Office Action Summary

10/586,392

HAGG ET AL.

DETAILED ACTION

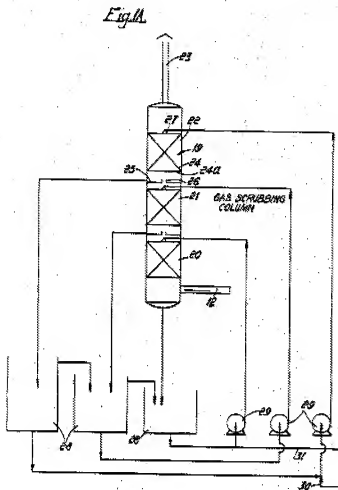
- (3). **Claims 1-3, 11** are rejected under 35 U.S.C. 102(b) as being anticipated by Warner et al (US 3528220).

As to a scrubber for the cleaning of gases containing several scrubber stages (1-4), where the scrubber stages are arranged in a scrubber tower with different stages at different levels above each other in the scrubber tower in **independent claim 1**, Warner et al (US 3528220) disclose avoidance of air pollution in the manufacture of glass fiber products (Title). It is further shown in the Figure below, the gas scrubbing column has polluted air stream inlet 12, three scrubbing stages 20,21 and 22 arranged as claimed.

As to characterize in that at least one of the scrubber stages (2-4) above the lowest scrubber stage (1) comprising a ring-shaped tank (10,15,20) arranged inside the scrubber tower which ring-shaped tank (10, 15, 20) is arranged surrounding a central channel (9, 14, 20) is arranged surrounding a central channel (9,14,19) through which the gas that is to be cleaned can pass upward in **independent claim 1**, as shown in the Figure above, the liquid collecting tray 25, and chimney riser 26 are read on the limitations as claimed.

As to characterize in that all scrubber stages (2-4) above the lowest scrubber stage comprising a ring-shaped tank located inside of the scrubber tower in **claim 2**, as shown in the Figure above, it contains features as claimed.

As to characterize in that at each stage of the scrubber, a circulation pump is arranged to feed through feed pipes fluid present in the tank from the tank at the bottom of the scrubber stage to spray beams arranged at the upper part of the scrubber stage for distribution over the cross-section of the scrubber in a direction against the upwards gas flow in **claim 3**, as shown in the Figure above, the three circulation pump and spray 27 which reads on the limitations as claimed.

As to characterized in that each stage of the scrubber a circulation pump being arranged to feed through feed pipes fluid present in the tank from the tank at the bottom of scrubber stage to spray beams arranged at upper part of the scrubber stage for distribution over the cross-section of the scrubber in a direction against the upwards gas flow in **claim 11**, as shown in the Figure above the liquid collecting tray 25 at bottom of the scrubber stage and spray 27 as well as the piping line (not numbered) to the spray 27, which read on the limitations as claimed.

As to characterized in that the circulation pump being arranged connected to the ring-shaped tank and located at essentially the same level as the tank in **claim 6**, Warner et al (US 3528220) disclose the liquid collecting in the trays 25 draining into respective tanks 28 whence it can be re-circulated by pumps 29 to the respective spray (Col. 4, line 65-67). It would be obvious to have circulation pump at same level of liquid collecting tray because of rearrangement of parts. *In re Kuhle*, 526 F.2d 553, 188 USPQ 7 (CCPA 1975).

As to characterized in that the circulation pump being arranged outside of the ring-shaped tank and outside of scrubber tower, and connected by means of an inlet pipe to a connection on the tank in **claim 7**, as shown in the Figure above, the recirculation pumps are outside of the liquid collecting tray and a pipe is shown for the connection, it would have a connector for the connection between the liquid collecting tray and pipe for the convenience of maintenance as well known in the art of engineering practice. Also, it would place the pump on the ground because of rearrangement of parts. *In re Kuhle*, 526 F.2d 553, 188 USPQ 7 (CCPA 1975).
As to characterized in that a pump tank being arranged outside of the ring-shaped tank

As to characterized in that a pump tank being arranged outside of the ring-shaped tank and outside of scrubber tower directly connected to the tank through a connection and that the circulation pump is arranged in or connected to the pump tank in **claim 8**, as shown in the Figure above, the tank 28 reads on the limitations as claimed.

As to characterize in that the circulation pump being arranged on the ground outside of the ring-shaped tank and outside of the scrubber tower, and connected by means of an inlet pipe to a connector on the tank in **claim 9**, as shown in the Figure above, the recirculation pumps are outside of the liquid collecting tray and a pipe is shown for the connection, it would have a connector for the connection between the liquid collecting tray and pipe for the convenience of maintenance as well known in the art of engineering practice. It would place the pump on the ground because of rearrangement of parts. *In re Kuhle*, 526 F.2d 553, 188 USPQ 7 (CCPA 1975).

FIG. 1

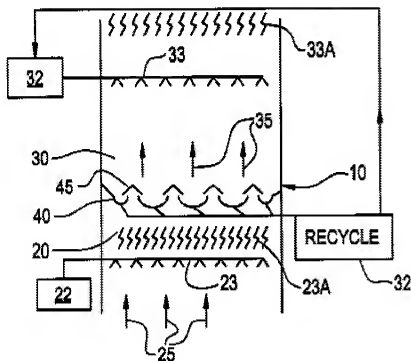
However, Nolan (US 6399030B1) teaches combined flue gas desulfurization and carbon dioxide removal system (Title). As shown in the Figure 1 below, it contains a series of baffles and drains 40. One or both of the drains 40 and baffles 45 may be oriented at an inclined angle toward a front or back of the wall of the vessel 10 to improve drainage of the 2nd reagent 32 from the vessel 10 for recycling (Col. 3, line 6-20).

The advantage of baffles and drains is to provide a simple, mechanical separator between the gas separation processes within the vessel (Col. 2, line 4-6).

Therefore it would have been obvious at time of the invention to install the baffles, drains of Nolan for the baffle plate for each scrubber stage in the vessel of Warner et al in order to attain the advantage cited above.
